**Cottonwood Trails**  
**SITE PLAN FOR SUBDIVISION AMENDMENT**

**Cottonwood Trails**  
 SITE PLAN FOR SUBDIVISION  
 AND BUILDING PERMIT

**Administrative Amendment**

January 10, 2001  
 Revised: February 13, 2002  
 Sheet 1 of 8

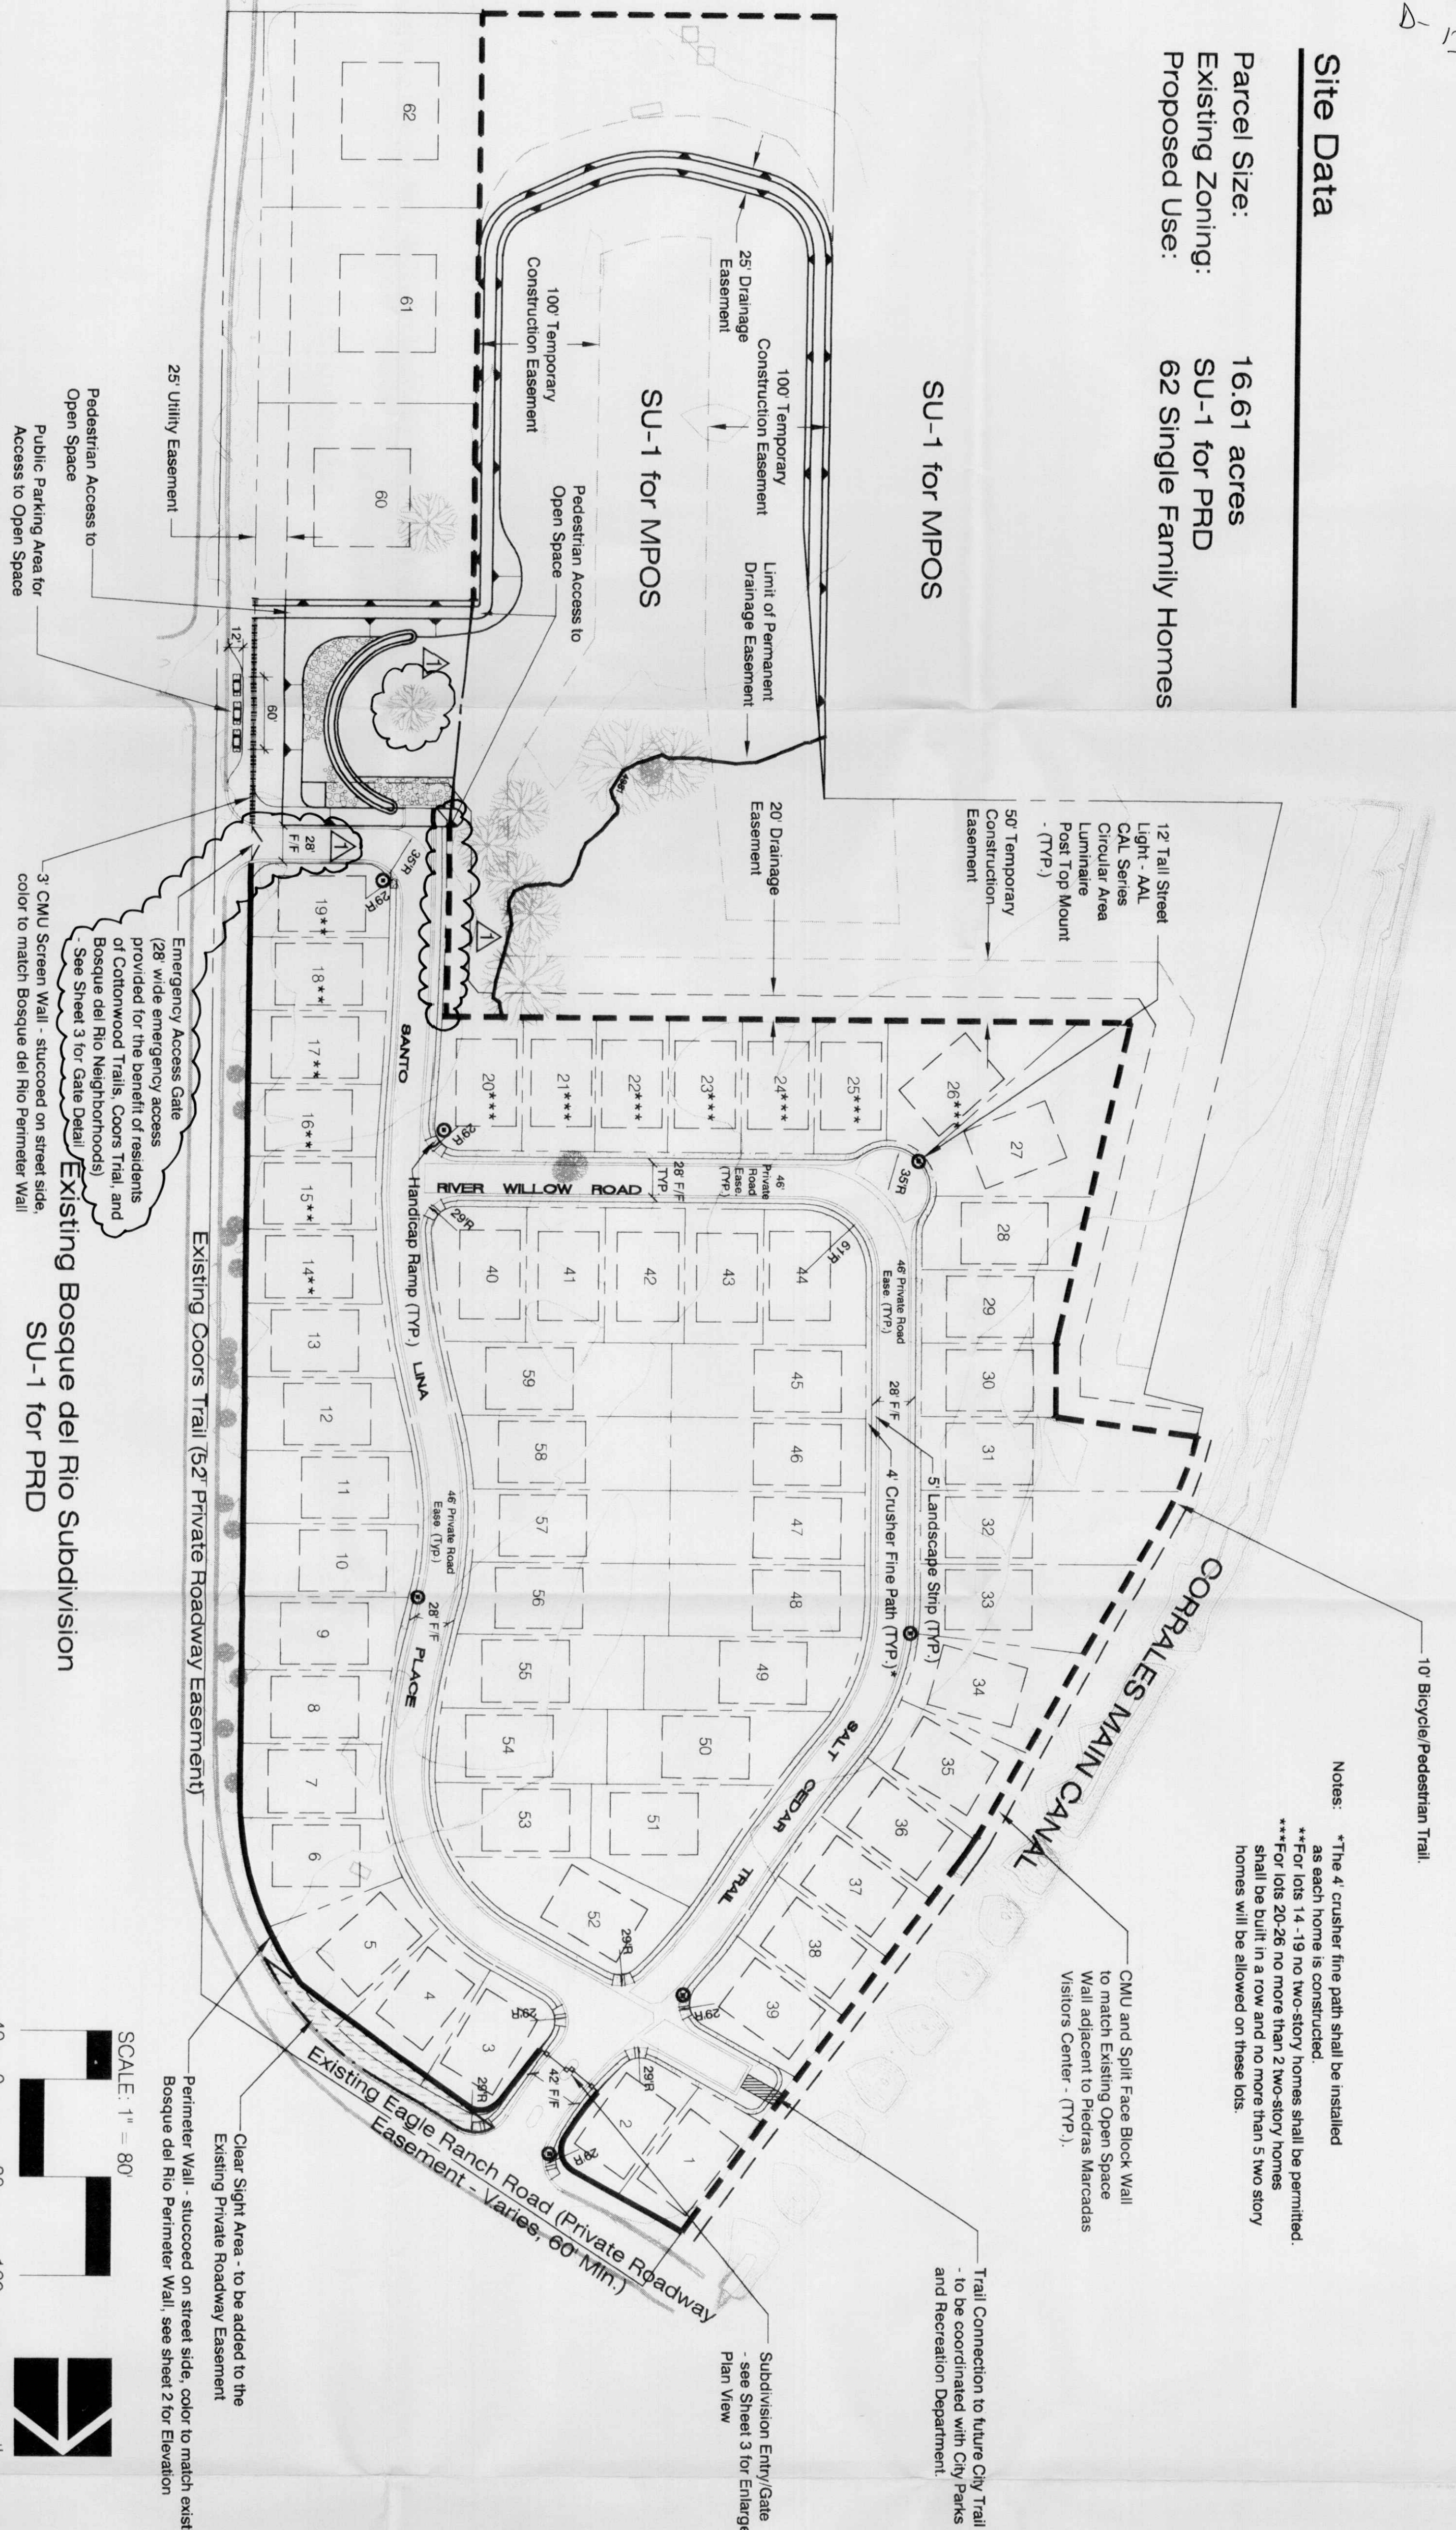
- Revised wall adjacent to City Open Space (Lots 18-26 & 60-62) to allow wrought iron view fencing (see new Sheet 3B).
- Added section of Open Space wall along the west side of Santo Lina Place (see Sheet 1).
- Revised note regarding existing cottonwood in the detention pond (see Sheets 2 & 3).
- Added Sheet 3B, Open Space Wall/Fence Plan.
- Modified Emergency Access per City DRC requirements (see Sheet 3).
